### 4.3 Nuclear Design

#### 4.3.1 Design Basis

Figure 4.3-4a (Sheet 1 of 4)

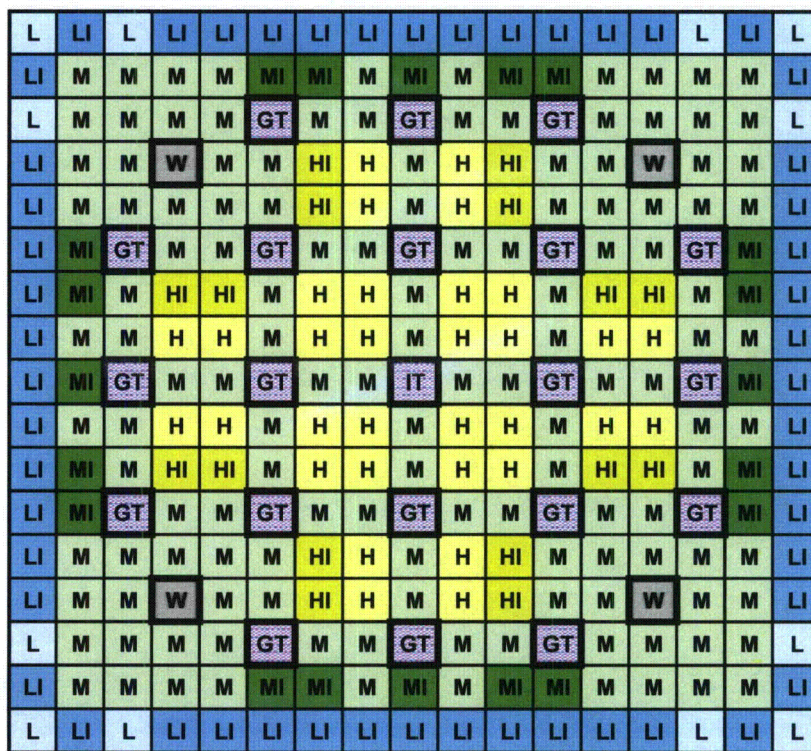
Comment [A75]: [4.3-75]

Figure 4.3-4a (Sheet 2 of 4)

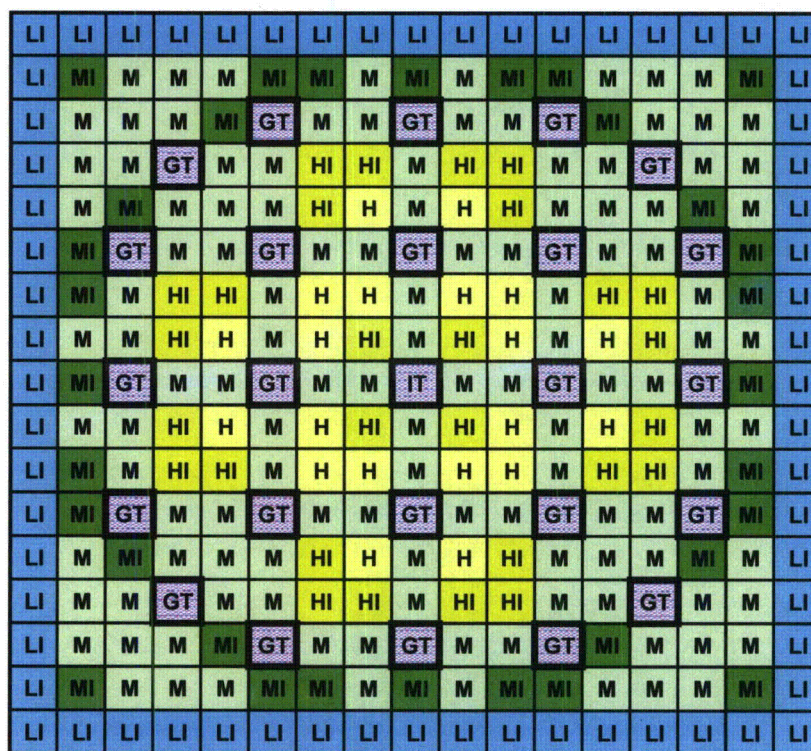
Comment [A76]: [4.3-76]

Figure 4.3-4a (Sheet 3 of 4)

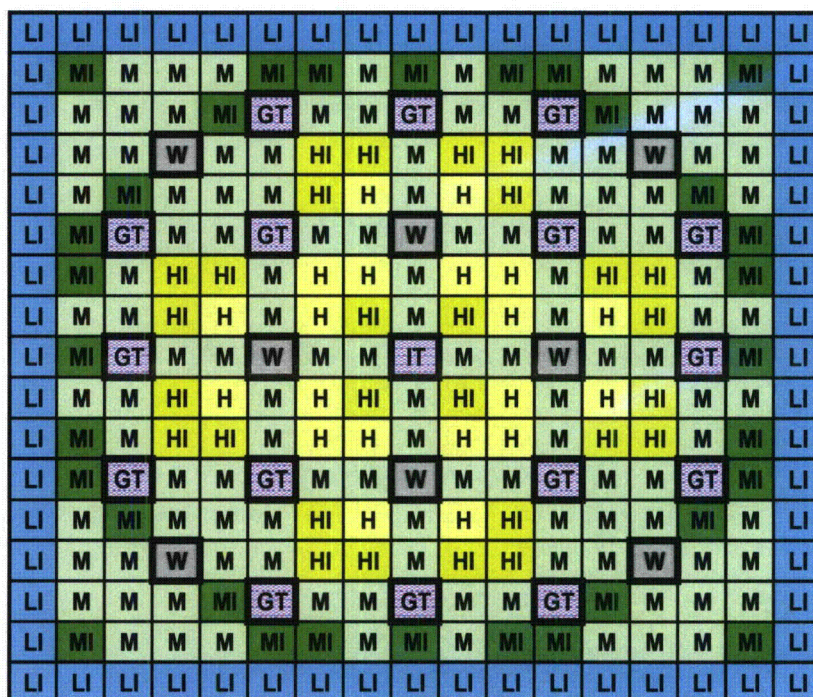
Comment [A77]: [4.3-77]

Figure 4.3-4b  
Cycle 1 Assembly Integral and Wet Annular Burnable Absorber Axial Configurations

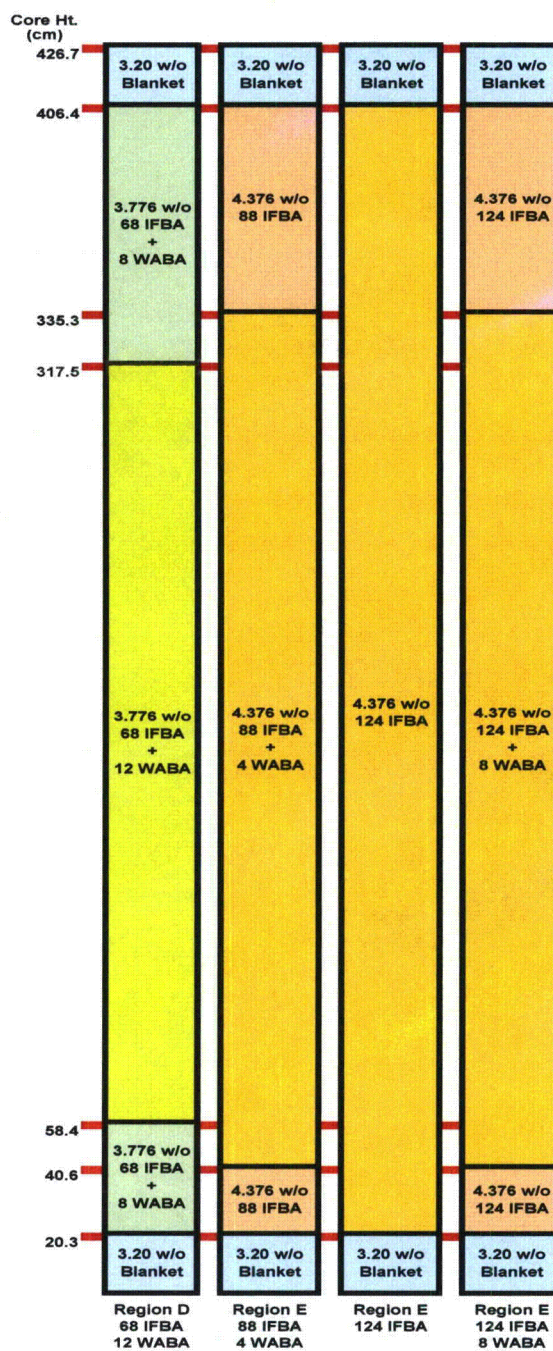
Comment [A78]: [4.3-78]

Figure 4.3-19

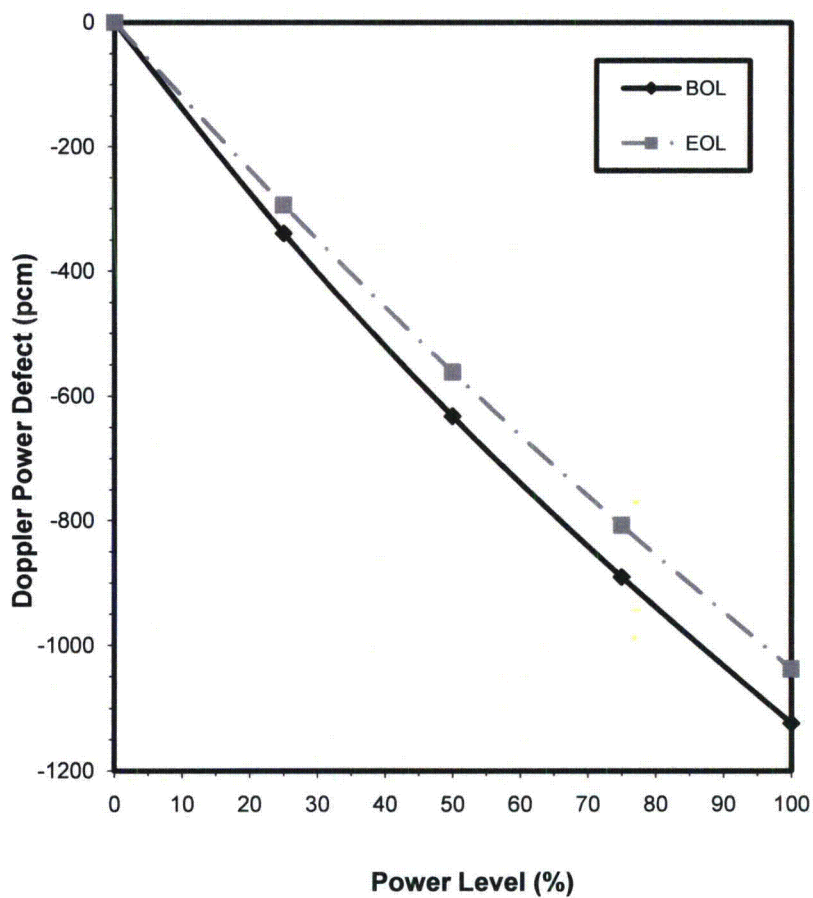
Comment [A90]: [4.3-90]

Figure 4.3-26

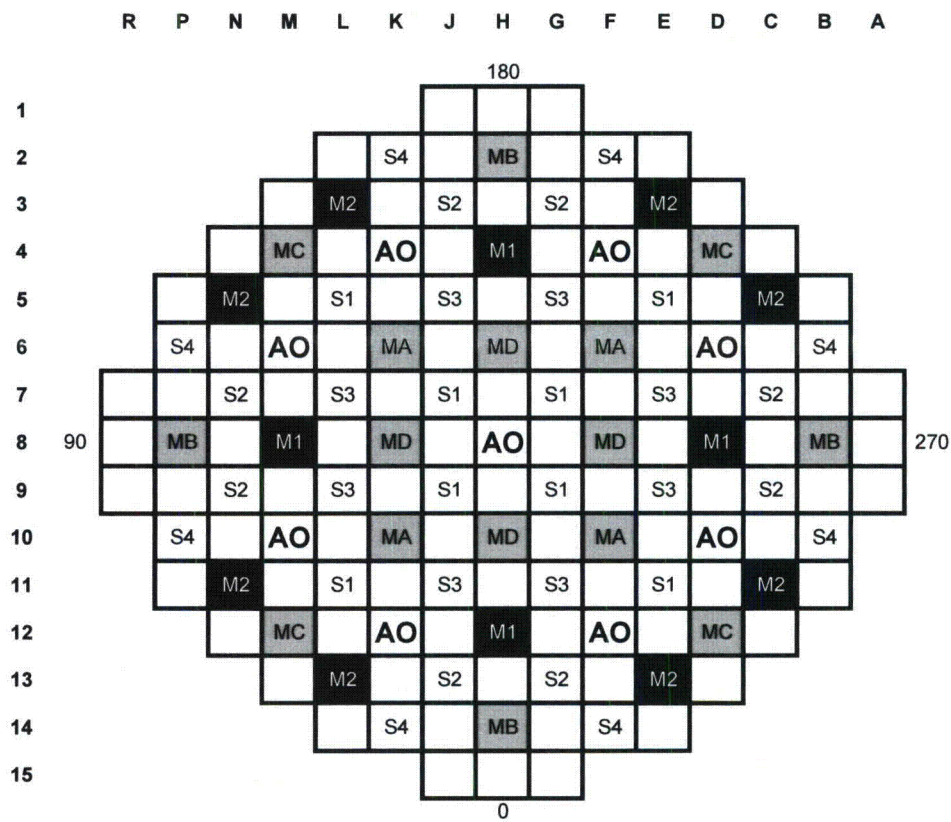
Comment [A94]: [4.3-94]
